RE: HISTORIC PRESERVATION COMMISSION AMENDMENT TO APPROVED APPLICATION NO. HPC2022 /154
BLOCK 242 / LOT 2 - ALSO KNOWN AS 100 Abbott Avenue

100 Abbott Avenue – Andrea – AMENDMENT to approved COA -review reports of windows & doors

100 Abbott Ave. Condition Report

1B and 1C

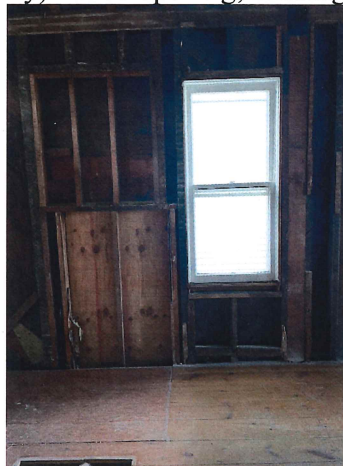
- 1B (north) - older 1/1 with a rebuilt frame and missing sill
- 1C (north) - older 1/1 with original frame and missing sill

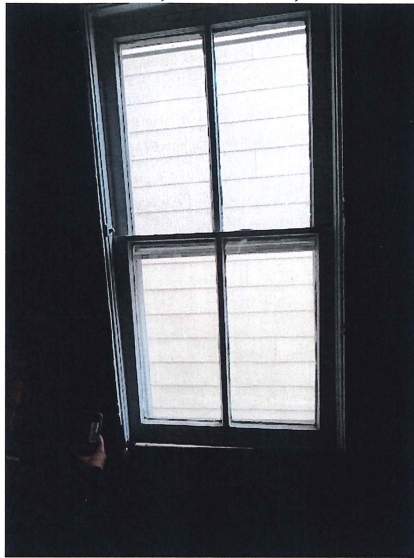
- 1F (west) - older 1/1 in (probably) added opening; missing sill

- 1H (west) - older 1/1; original frame and missing sill

1Q and 1R

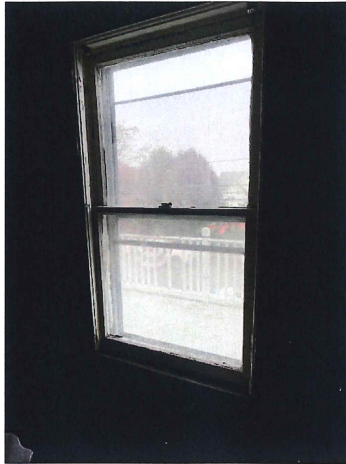
- 1Q (east) - historic 2/2; frame in need of repair
- 1R (east) - historic 2/2; frame rotted; sill missing

2B

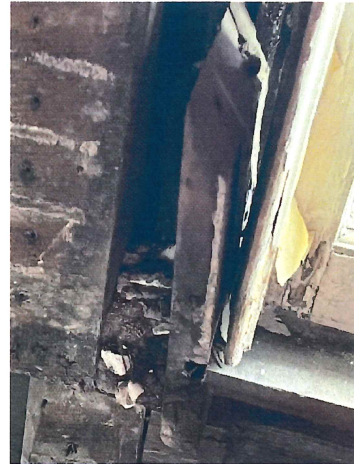
2B (north) – historic 2/2; screws hold sash together; missing sill; frame in poor condition

2C (north) – older 1/1; frame rotted

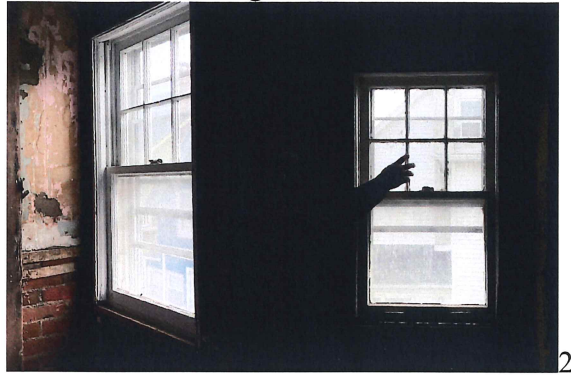
- 2E (west) - older 1/1
- 2F (west) - historic 2/2; frame in disrepair

- 2G (south) – older 1/1

3B with detail of sill

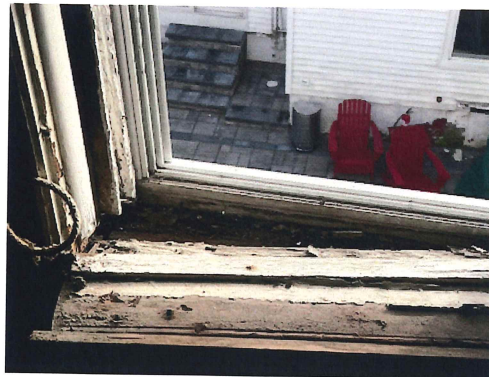
3A – older 1/1; rotted frame and sill

3B – older 1/1 with plexiglass replacement, frame and sill rotted
